## SERVICE BULLETIN

**Title:** 17/19EX Sticking Float Valves  
**Models Affected:** 17/19EX

**Number:** C9724  
**Date:** 8/8/97  
**Supersedes:** New

**Figure 2**  
**Float Assembly Width and End Clearance**

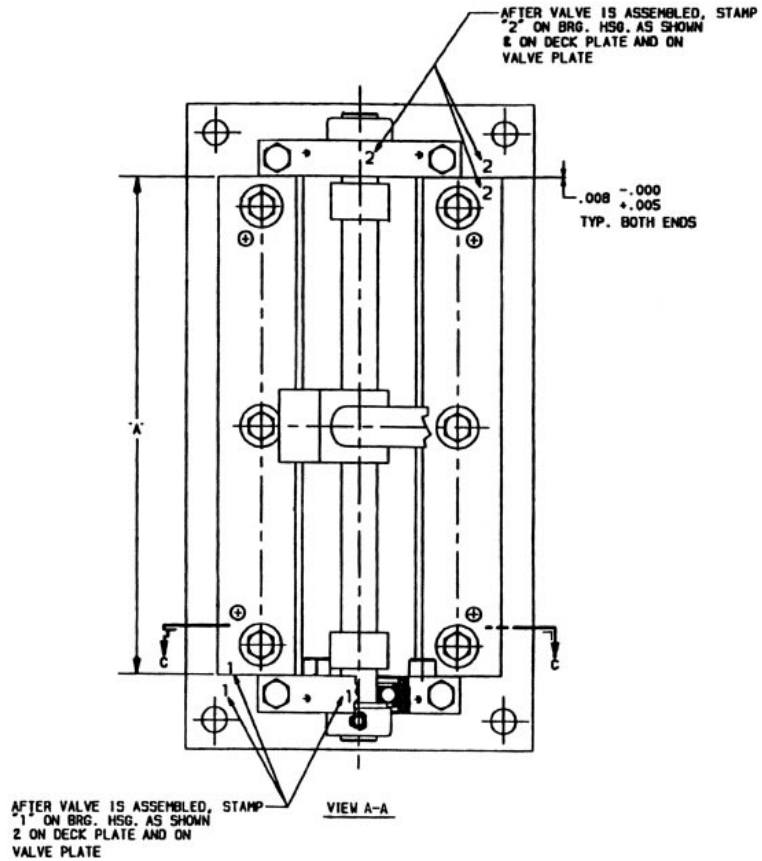
When lifted by hand, the float ball should move freely throughout its range of motion. If the float ball does not move freely, check to be sure that the float's shim plates are not binding against the float's swing plate. The recommended factory clearances are shown in Figures 2 and 3. Once assembled, the valve should rotate throughout its range of motion with a minimum clearance between the swing plate and the shim plate of  $0.060 \pm 0.005$  inches ( $1.5 \pm 0.1$  mm). It is easier to check the clearances from the under side of the float assembly.

Float Valve	09EX44007501	09EX54001301
Float Size	1	2
Plate opening (See Figure 4)	2.24 in. (56.9 mm)	2.24 in. (56.9 mm)
Shimmed opening (See Figure 4)	1.90 in. (48.3 mm)	1.90 in. (48.3 mm)
“A” Dimension (See Figure 2)	7.025/6.995 in. (178.4/177.7 mm)	8.595/8.565 in. (218.3/217.5 mm)
Approximate Full Open, shimmed “B” Dimension (See Figure 4)	1.25 in. (31.8 mm)	1.51 in. (38.4 mm)
Approximate Full Angular Travel	45°	55°
Knife Edge Clearance (See Figure 3)	0.020 ± 0.005 in. (0.508 ± 0.127 mm)	
Blunt End Clearance (See Figure 3)	0.060 ± 0.005 in. (1.524 ± 0.127 mm)	
Shim/Block Clearance* (See Figure 2)	0.008 –0.000/+0.005 in. (0.203 –0.000/+0.127 mm)	
Float Ball	EC28HZ243	
Ball Diameter	8.0 in. (203.2 mm)	
Ball Weight	41 ± 2.5 oz (1.16 ± 0.07 kg)	
Ball Displacement	268 in. <sup>3</sup> (4.4 L)

**Note:** \* — The clearance between the shims and the bearing housings must not be less than 0.016 in. (0.406 mm) total for the two ends.

**Figure 5**  
**High Side Float Chamber**

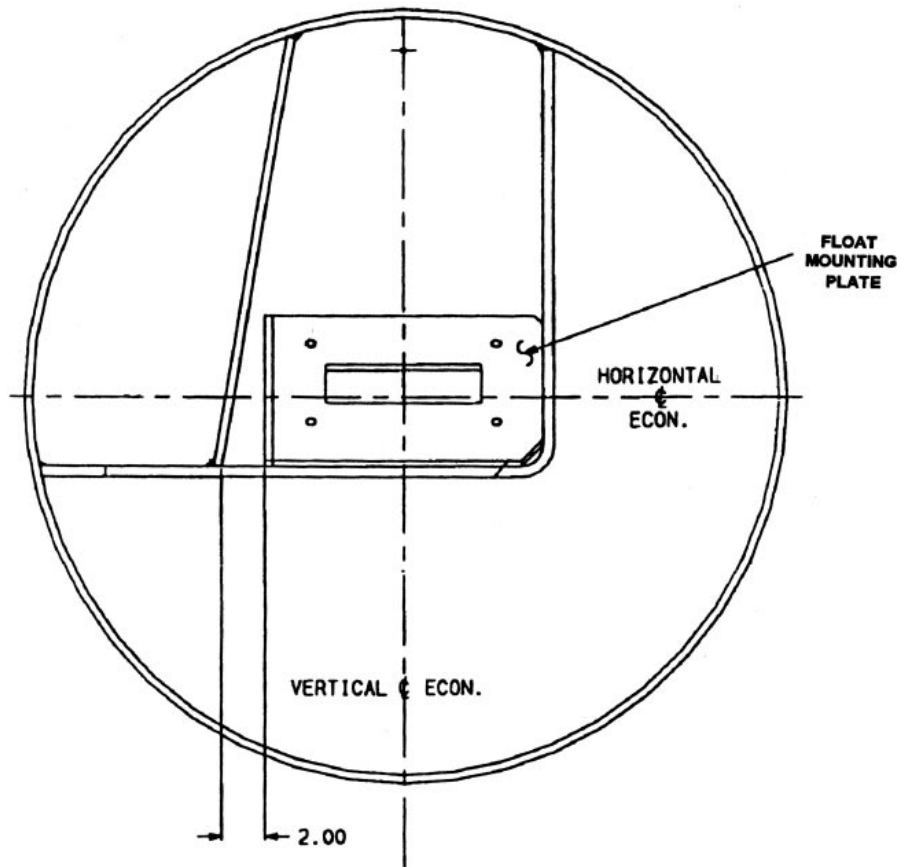
There have been several reports from the field of low cooler pressure alarms on 17/19EX machines. In most cases, this phenomenon has been traced to a stuck float valve in the economizer. The problem can be attributed to the steel plate that the float valve mounts to in the economizer warping during the welding process (See Figures 5 and 6). This causes the float's mounting plate to twist slightly, and the bearings to bind.
